## Section 7: Spent Fuel Pool Integrity Evaluation

## 7.2 Evaluation Process for the SFP

Figure 7-1  
Basic Process for Evaluation of Potential Failures for SFP Penetrations

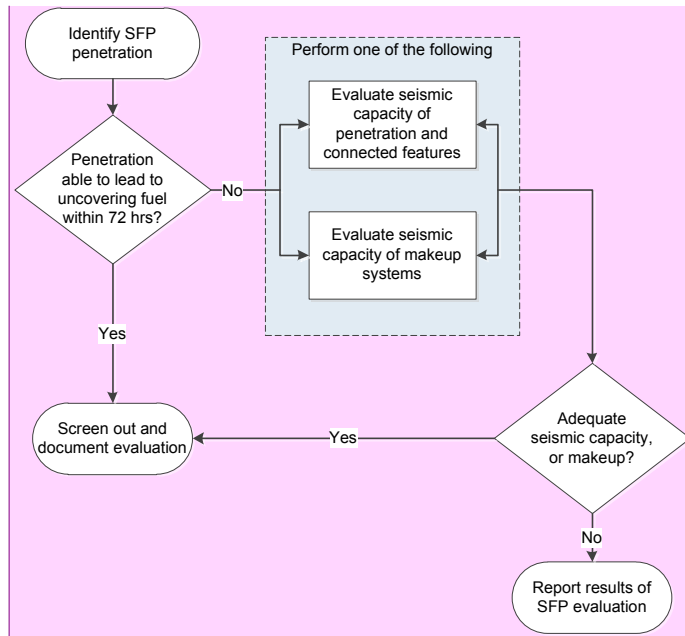
**Comment [AK9]:** The first set of yes and no are reversed. The arrows go both ways between the “perform one of the following” box and the “adequate seismic capacity” diamond. The arrows going into the box should be removed.
